**ADDENDUM NO. 2**

Date of Addendum: February 7, 2023

Project Name: Gaston County Schools – Grier Middle School

- A. Owner: Gaston County Schools
- B. Architect: LS3P
- C. Architect Project Number: 9201-218240

S-203

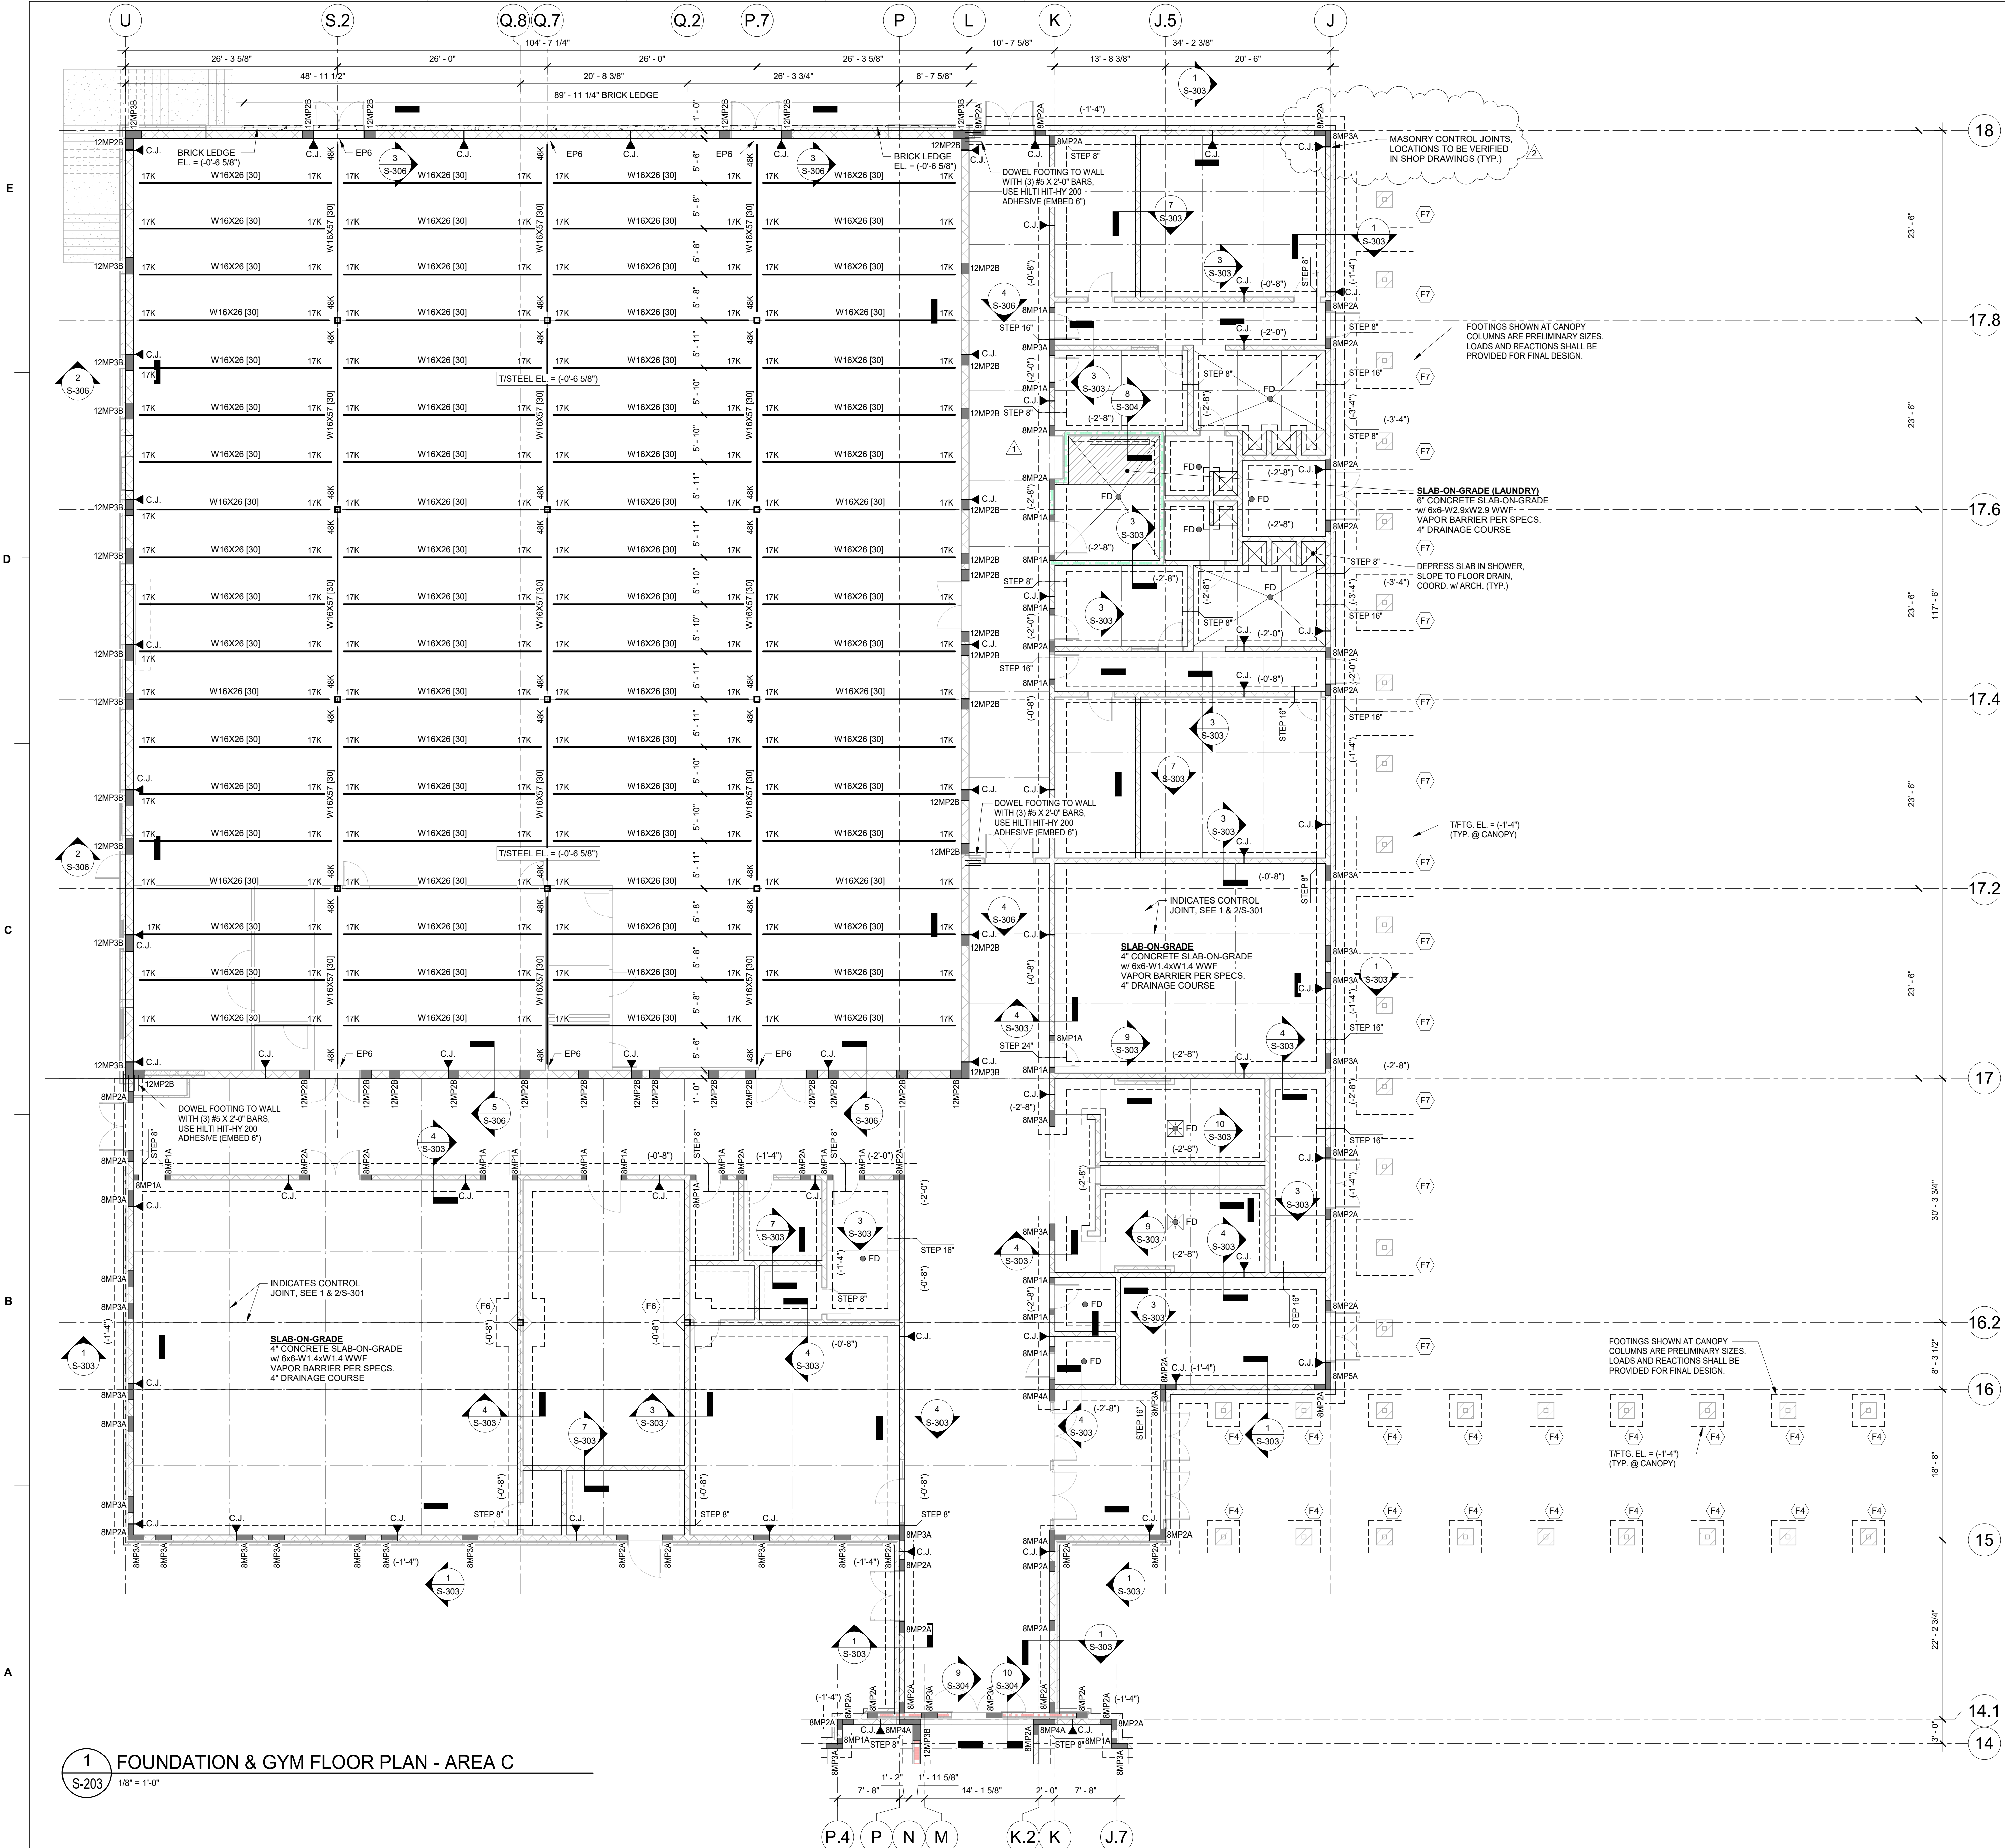
- Q. Replace SHEET S-203 – FOUNDATION & GYM FLOOR PLAN – AREA C with revised Sheet S-203, included in the attachments.
    1. Added masonry wall control joint locations. Clarified finished floor elevation.

S-212

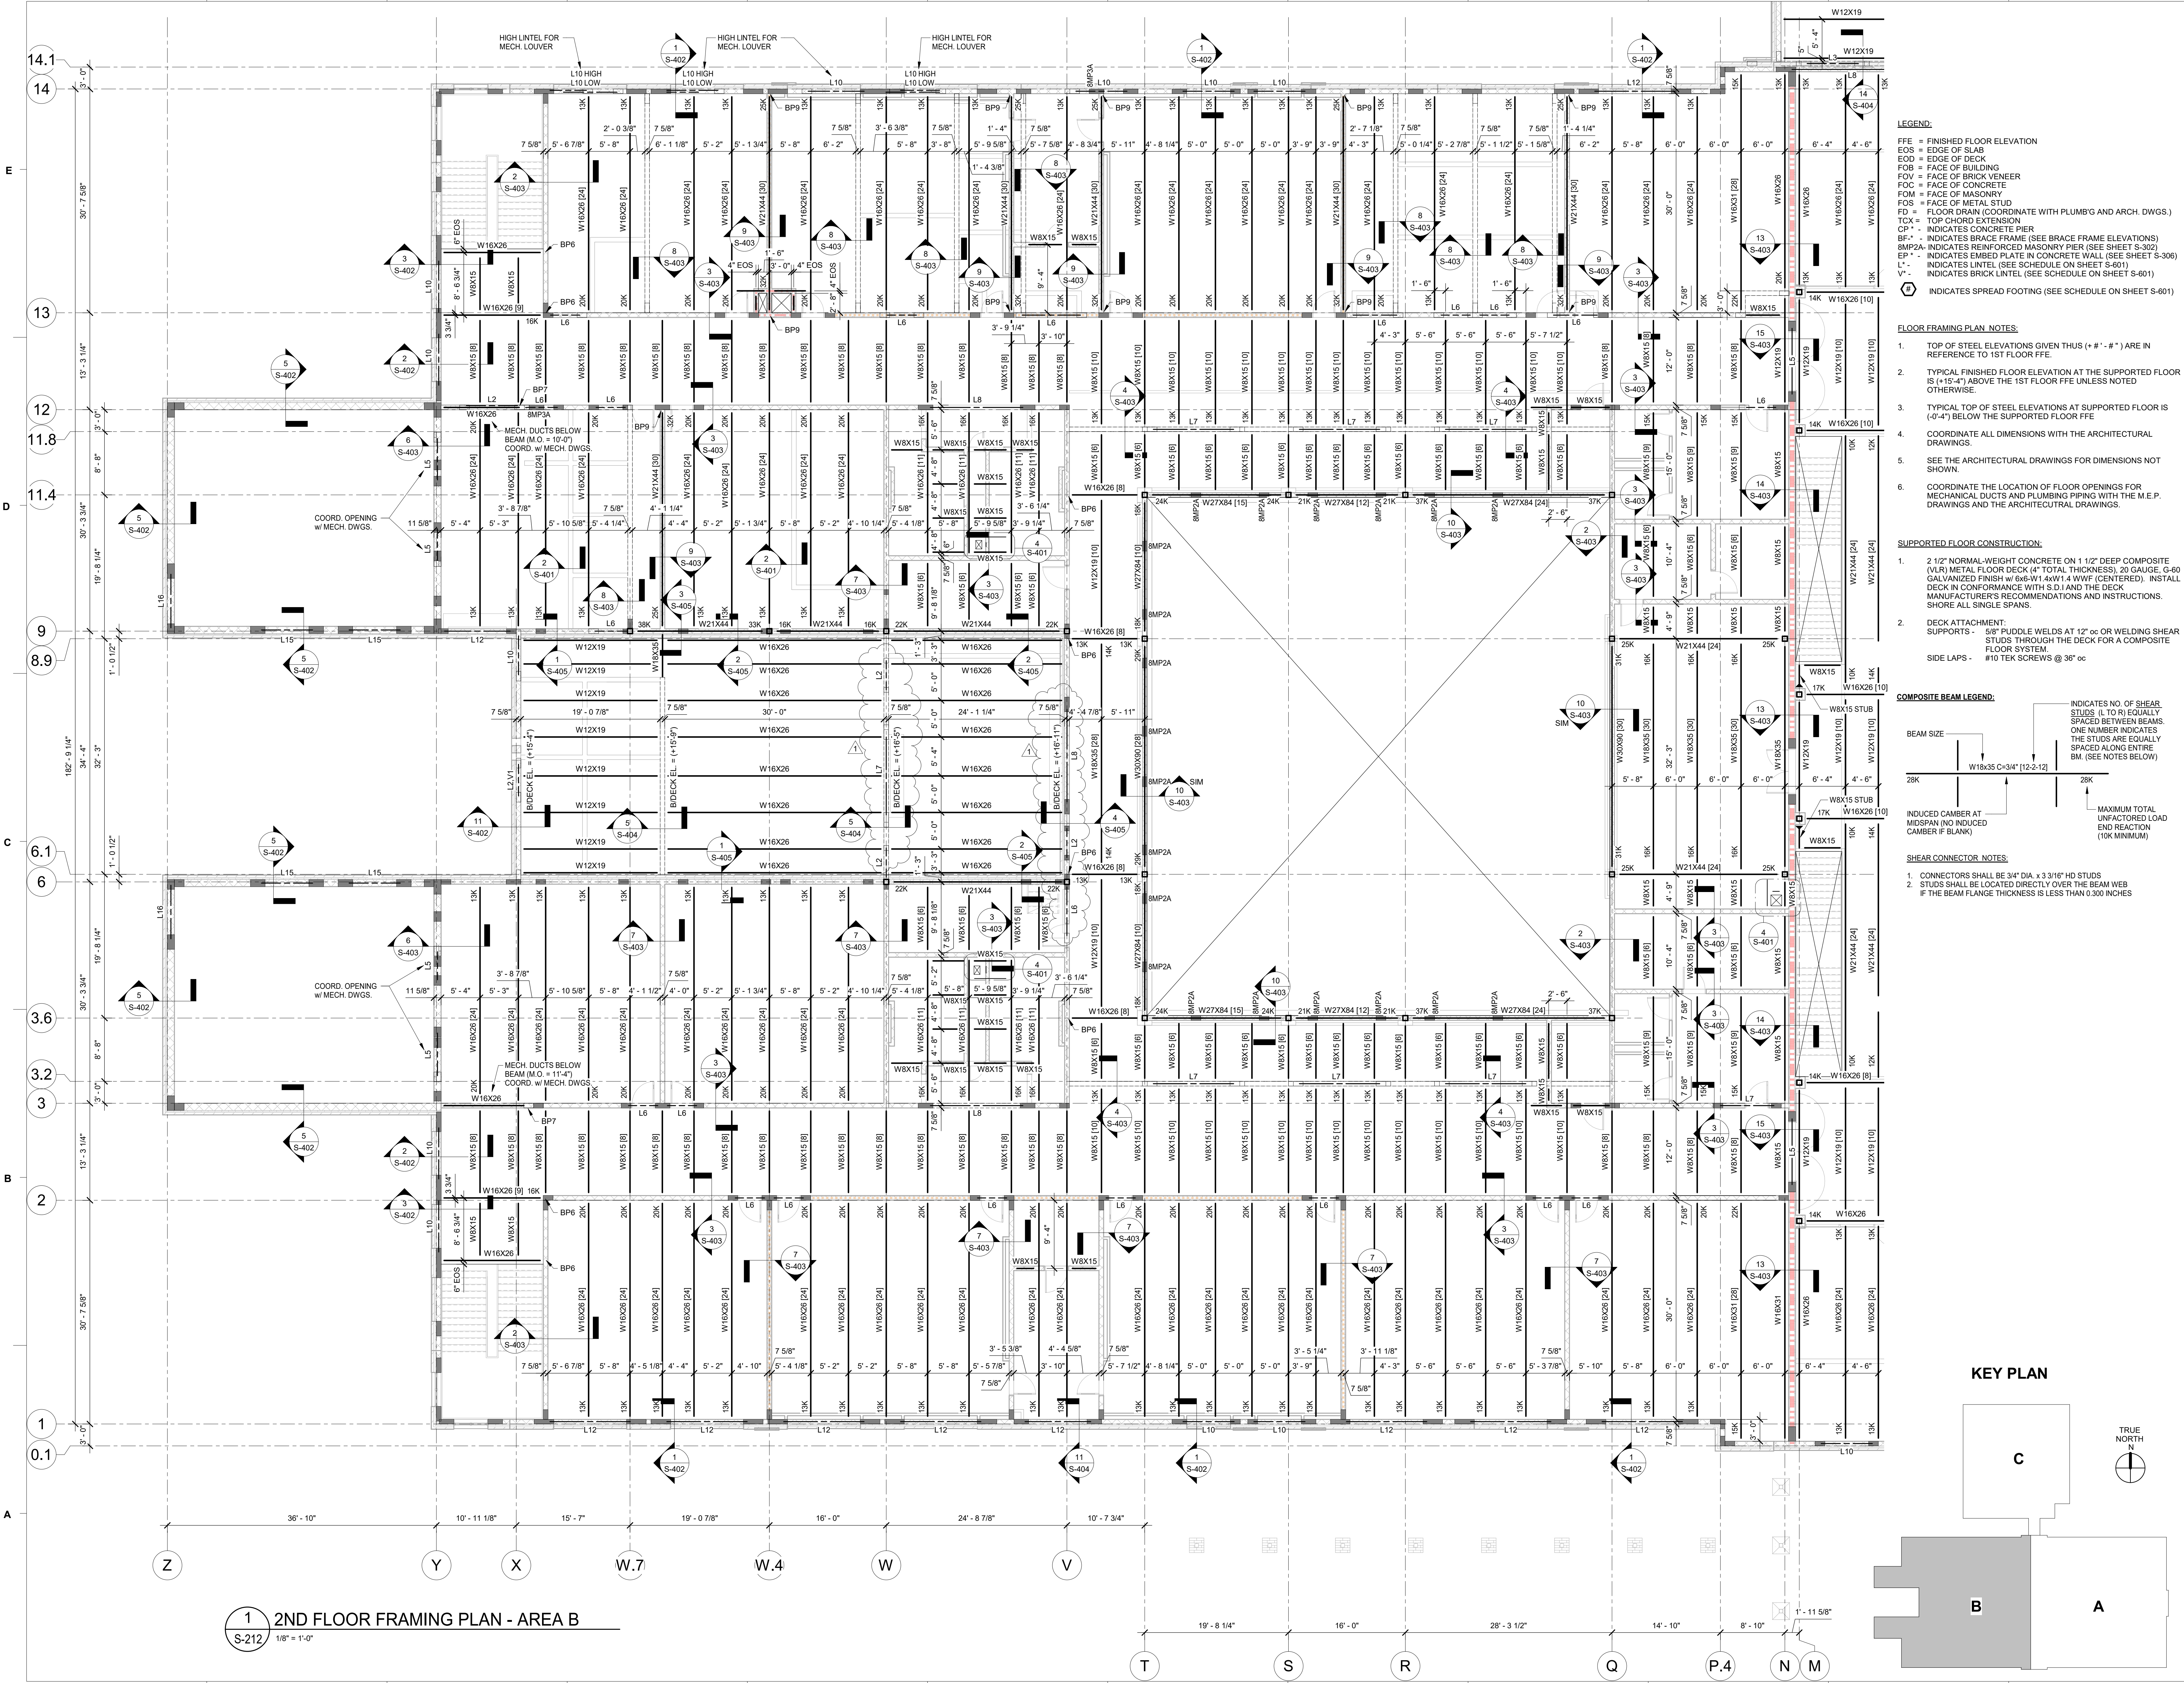
1. Added lintel callouts at CMU walls along grid lines V and W.
- T. Replace SHEET S-221 – ROOF FRAMING PLAN – AREA A with revised Sheet S-221, included in the attachments.

S-221

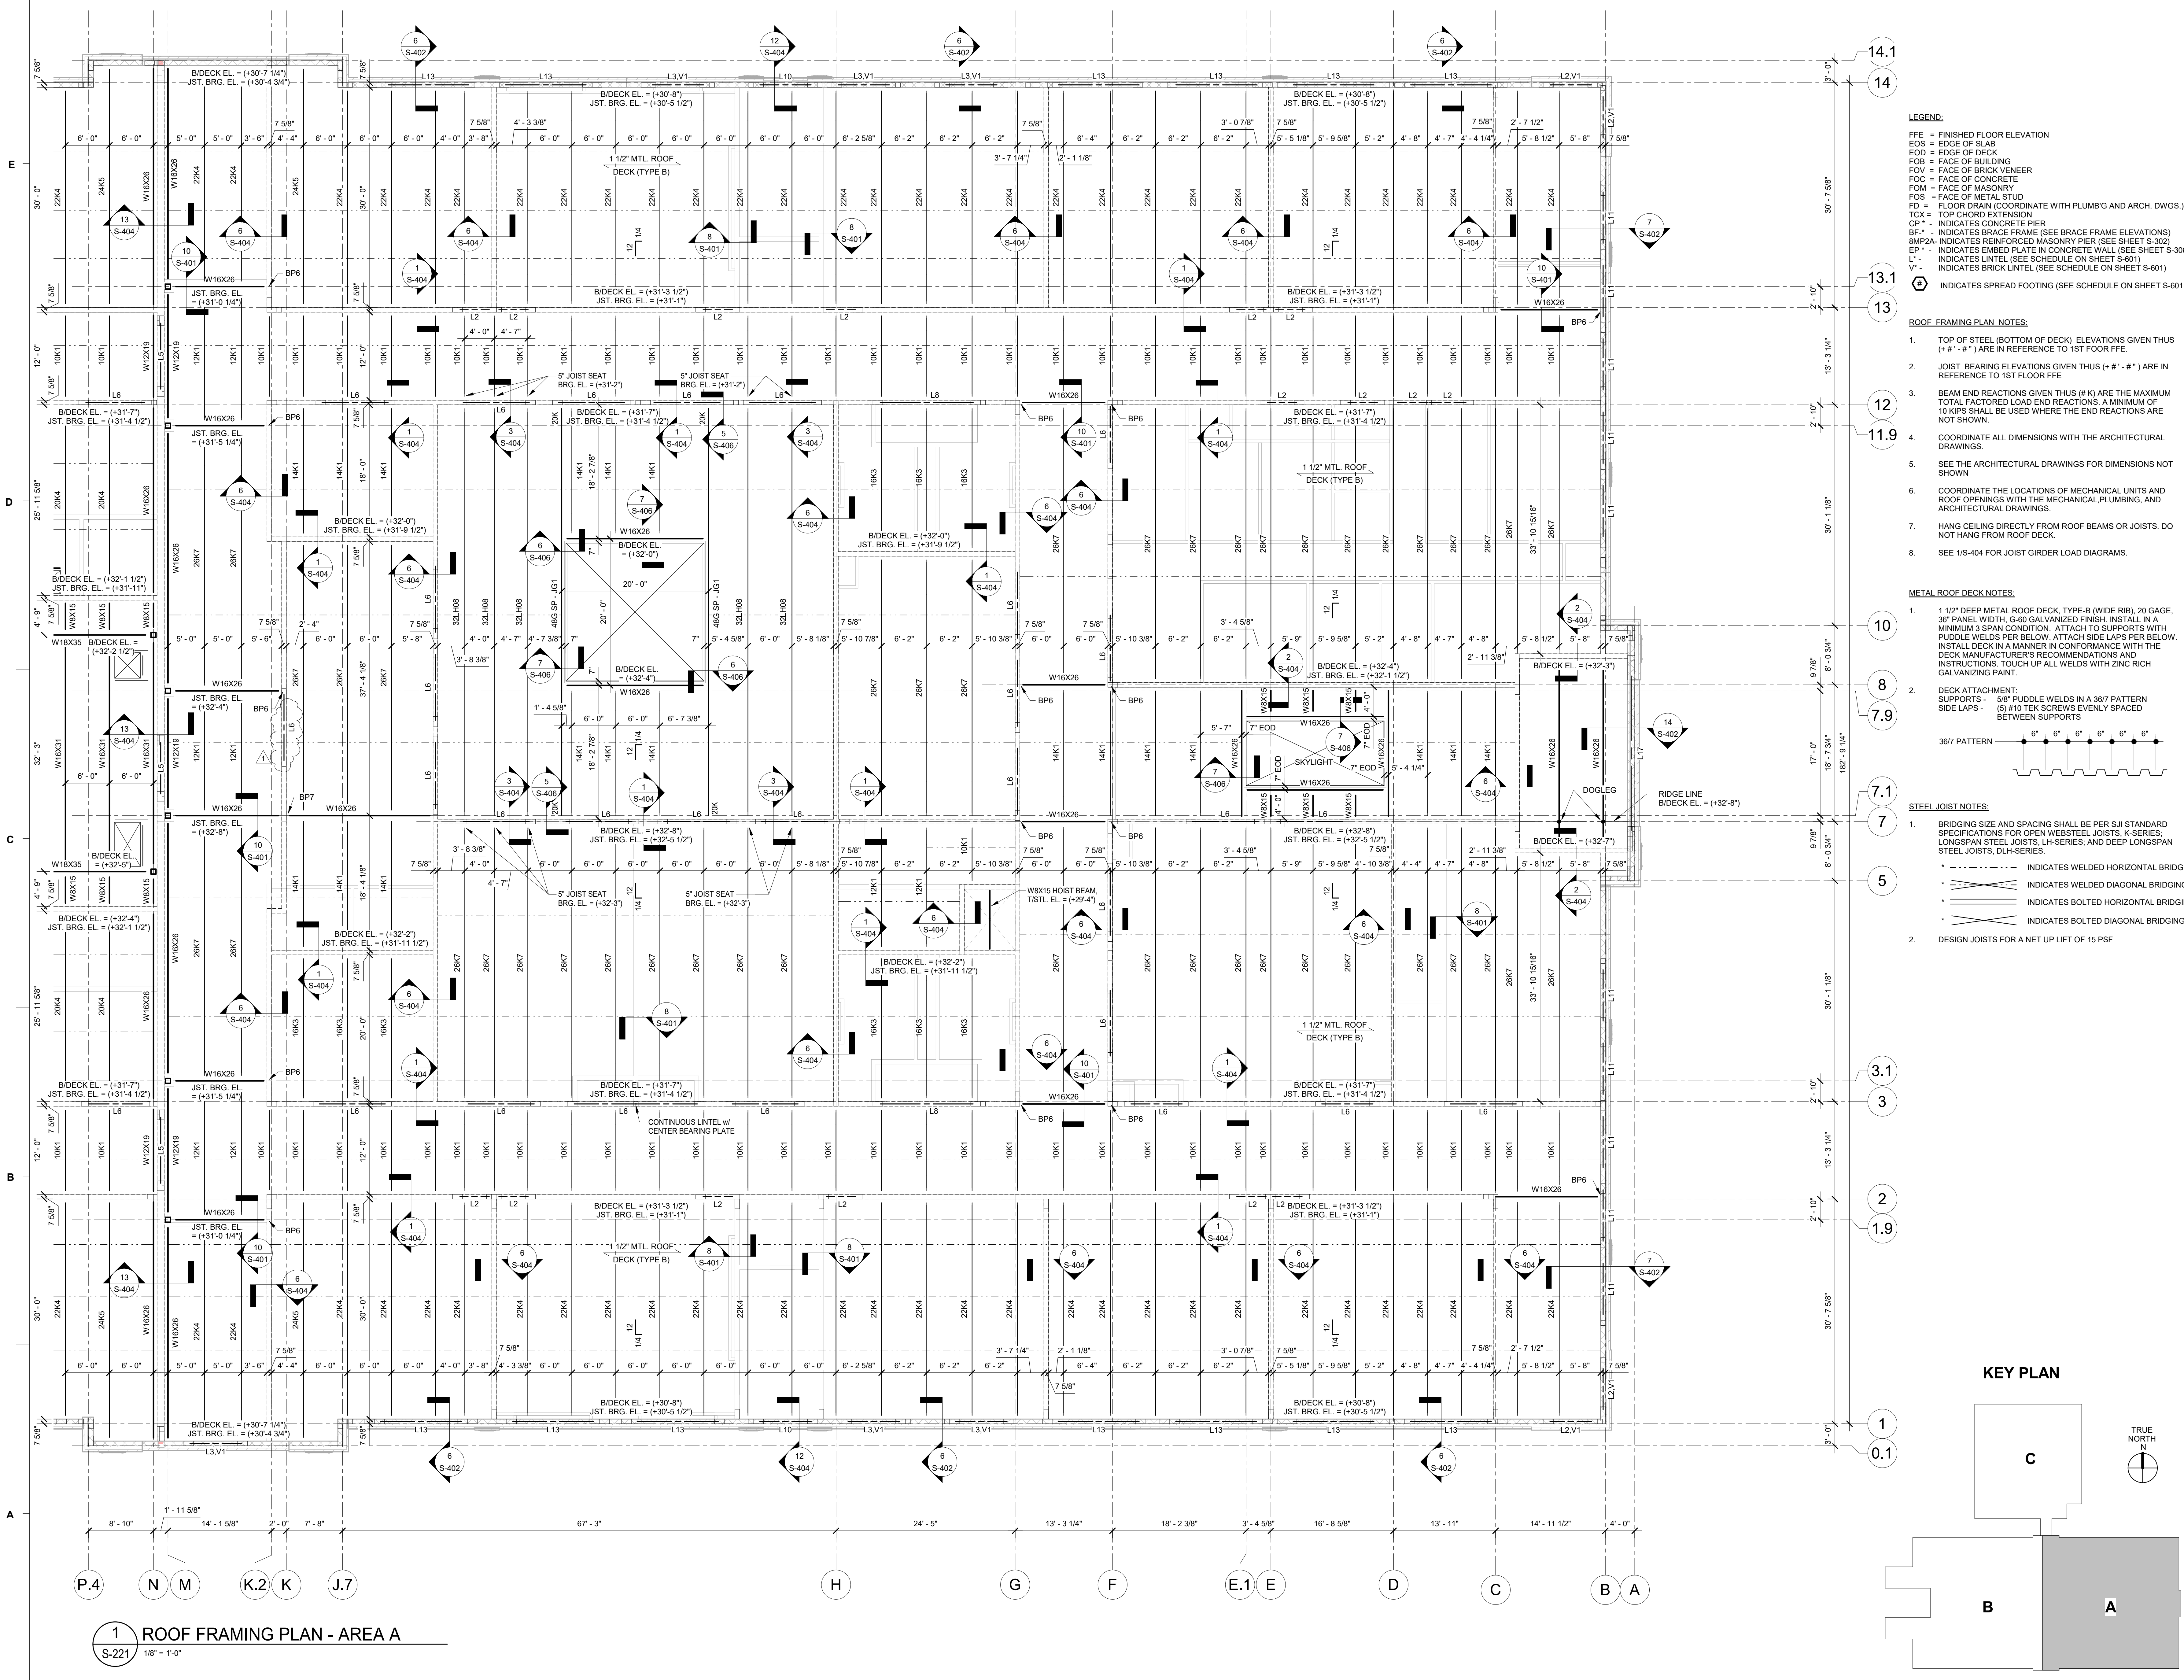
1. Added lintel callouts at CMU wall along grid line K.
- U. Replace SHEET A-715 – CASEWORK LEGEND & SCHEDULE with revised Sheet A-715, included in the attachments.
